Safety of Rodney House Roundabout

This report has been prepared by Paul Davis, Chair, Graven Hill Residents' Association (GHRA), and a resident of Graven Hill for six years.

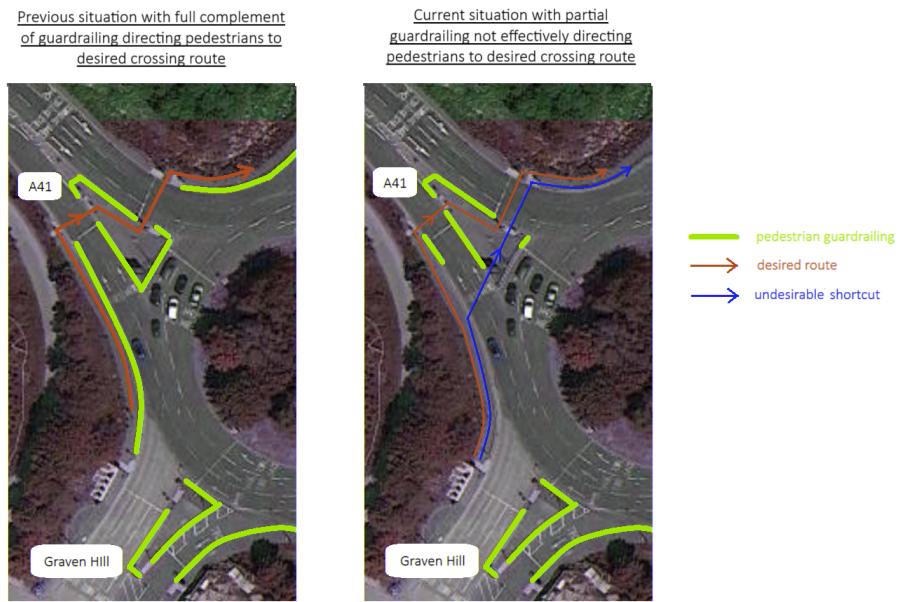
- Removal of pedestrian guardrailing

The main purpose of pedestrian guardrailing is to direct pedestrians to the appropriate crossing point [Department of Transport, *LTN 2/09 Pedestrian Guardrailing* (April 2009), section 1.3.5, p.5, <https://assets.publishing.service.gov.uk/media/6116584a8fa8f53dc5ce0f76/ltn-209-pedestrian-guardrailing.pdf>]. A substantial portion of guardrailing at the roundabout was recently removed. This is highly problematic as impatient pedestrians seeking a shortcut can now cross much closer to the roundabout. In doing so, pedestrians will have less visibility of (speeding) vehicles coming around the roundabout, and

those drivers have less visibility of pedestrians crossing in an unexpected place. The fact that the guardrailings removed had been frequently mangled by vehicles losing control amplifies the significance of this point.

This is the case now for crossings on the East and West exits of the A41. The diagrams above show before and after views of the pedestrian crossing on the west exit of the A41. In the left image, the guardrailings used to guide pedestrians to the crossing about 20m away from the junction. The image on the right shows that because of the switchback on the central island to the second part of the crossing, the removal of guardrailings now provides a clear shortcut and desire path.

It is not obvious why the guardrailings were not replaced or alternatively, why other mitigating measures, such as a reduction in speed limit, not applied [DoT, 2.1.8. p.8]. It is true that studies have shown that the removal of guardrailings can lead to less accidents [DoT, 3.3.2, p.14] [Street Behaviour, Collisions Before And After Removal of Pedestrian Railings (July 2017), <https://content.tfl.gov.uk/pedestrian-railings-removal-report.pdf>].

However, results were very site specific, and not deemed significant for roundabouts, whilst also showing guardrailings at roundabouts were very effective at directing pedestrians to the correct crossing points [DoT, 3.3.4, p.14/15]. It is also indicated that the criteria for the removal of guardrailings should be based on how effective it is in directing pedestrians to the appropriate crossing point and so its removal at Graven Hill appears to be contrary to this guidance [DoT, 6.6.2, p.22]. Furthermore, it may be reasonably assumed that even when mangled, they were performing its intended role.

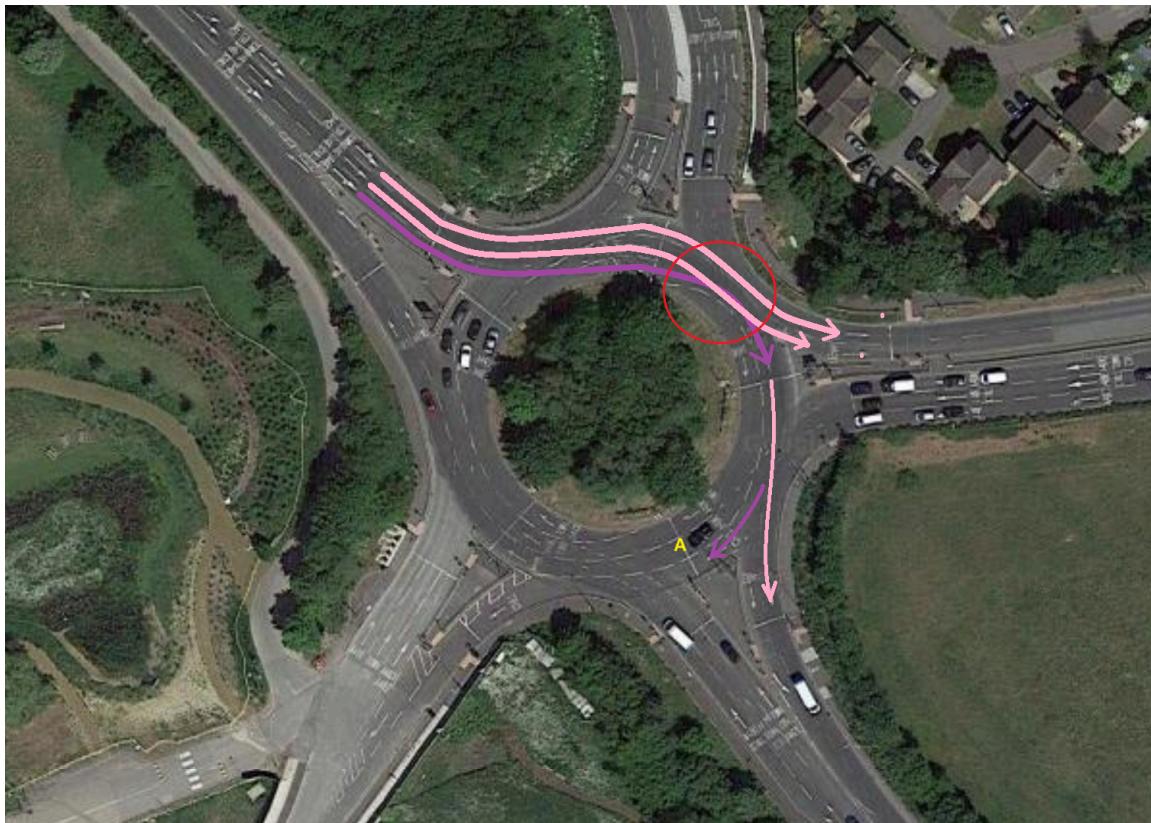
- Unintuitive merge required on roundabout

When entering the roundabout on the A41 from the west, traffic to Graven Hill needs to merge with traffic from the lane to the left staying on the A41 and heading east. This requires an unnatural change in line such that it looks like you are swerving into the natural line of the vehicle on your left. This is very problematic and causes a lot of confusion, some shunts and many near misses.

In the above diagram, consider a vehicle approaching from Oxford on the A41 (upper left) and travelling to Graven Hill. They stop at the roundabout in the right-hand lane. To their immediate left is a car travelling onwards to Aylesbury. Both cars are directed to merge into a single lane whilst on the roundabout, as shown by the red circle. The car travelling to Graven Hill (purple line) is explicitly directed away from the lane hugging the roundabout. So, for example, the car marked with an A in the diagram is not travelling to Graven Hill.

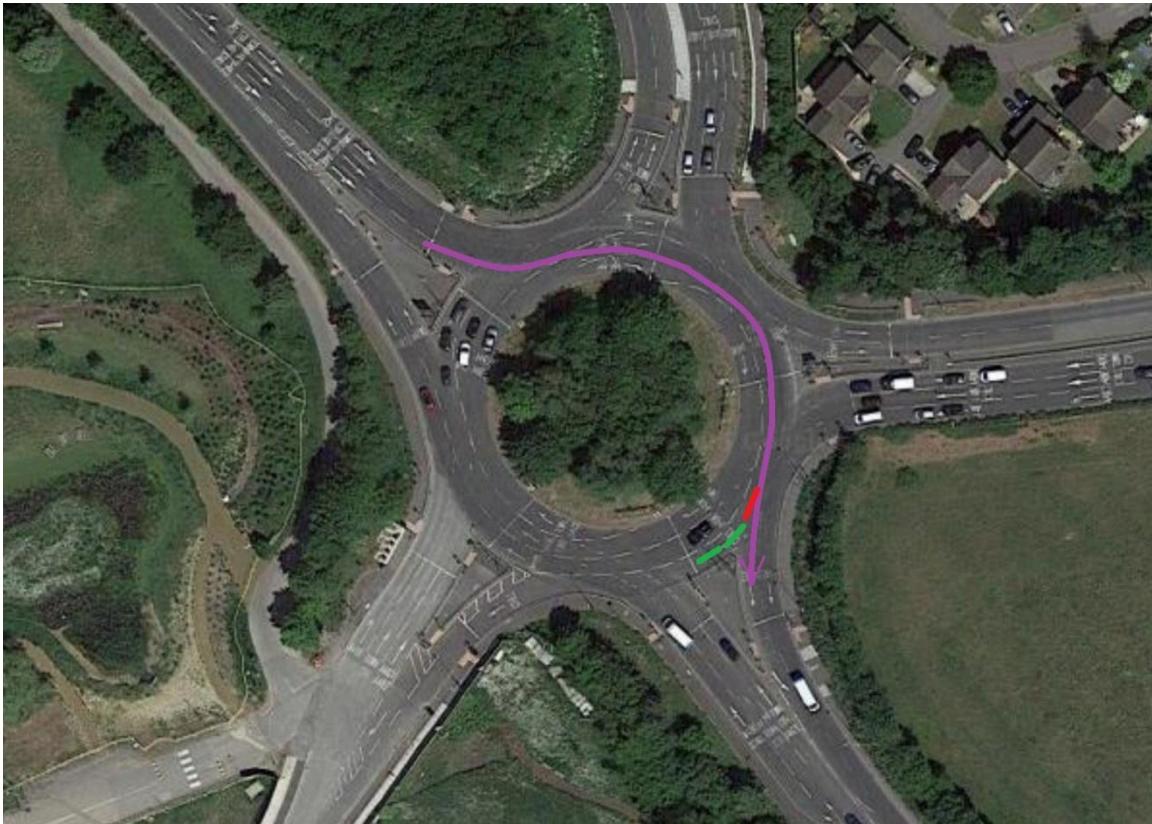
- Phasing on roundabout leads to stationary vehicles in path of unsuspecting traffic

When on the roundabout and waiting at the last set of traffic lights before entering Graven Hill, there is only room for two cars. A third car will overhang the roundabout exit heading east on the A41 and is vulnerable to being hit by vehicles either not paying attention or

speeding. This has been the cause of a number of accidents and near misses (dashcam footage on one such accident is available on request).

In the image above, there is a car waiting at the set of traffic lights on the roundabout immediately before traffic coming from the Aylesbury direction on the A41. As mentioned previously, this car is not travelling to Graven Hill as the lane markings indicate traffic for the A41 and London Road. A car travelling to Graven Hill stops alongside them to their left. If a few vehicles, also heading for Graven Hill, are waiting then the third (as indicated in red) overhangs the roundabout exit for the A41 to Aylesbury. The situation is compounded if the first vehicle is larger than a car, then there only needs to be two vehicles travelling to Graven Hill for there to be a potential problem. It is also particularly the case for traffic that has entered the roundabout on the far-right lane and continuing east on the A41 (as shown by the purple line).

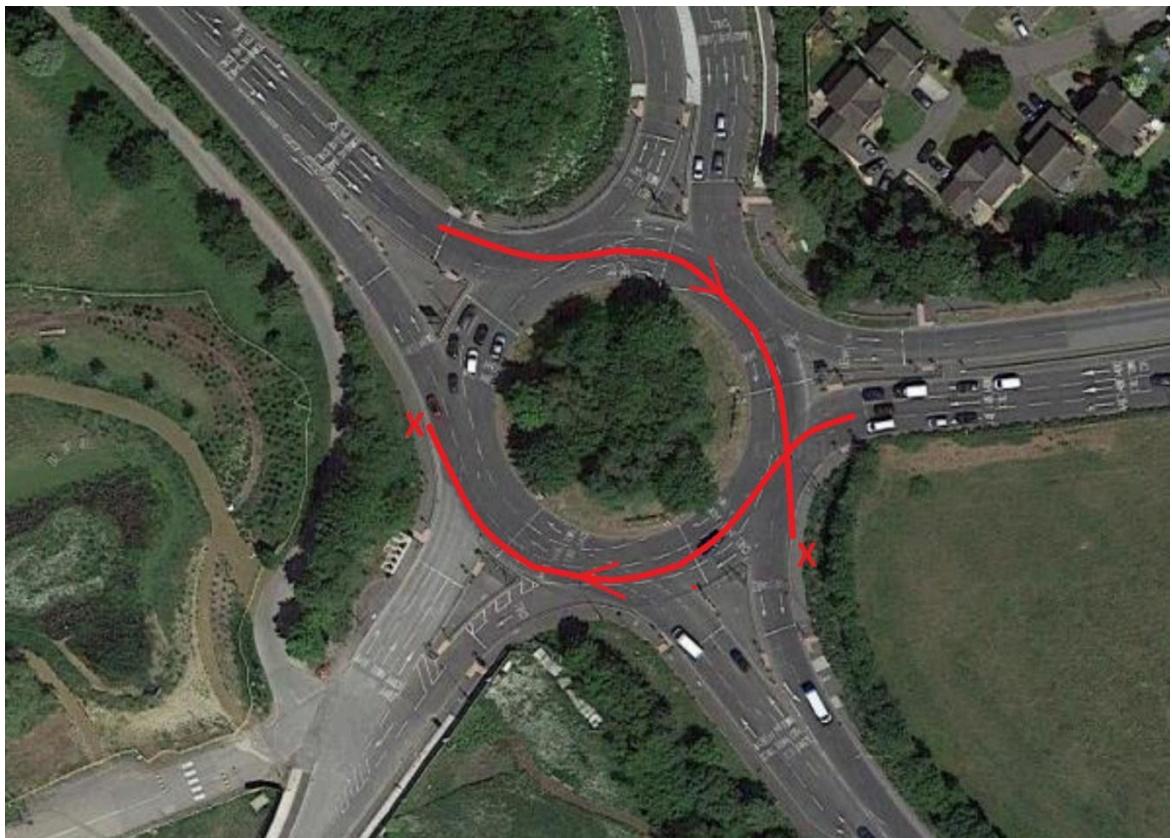
- Drivers losing control on the roundabout

Many vehicles negotiate the roundabout too quickly and lose control on exit. This is particularly so for the two A41 exits, as evidenced by the frequent damage to guardrailings on these exits by the crossings.

The following diagram shows the two key problem points (marked "X"), although mishaps have happened with guardrailing elsewhere on the

roundabout too. The corresponding paths for those vehicles that run into trouble are indicated in red on the diagram and are consistent with where a vehicle might lose control if driving too fast.

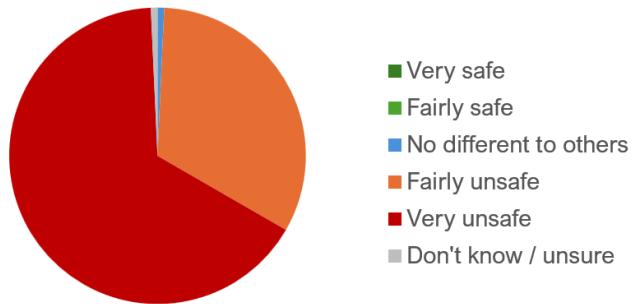
- Drivers fail to stop at on-roundabout traffic lights

Residents frequently experience vehicles ignoring the red traffic light signals on the roundabout. This is particularly the case directly by Graven Hill (seen by drivers waiting to leave Graven Hill).
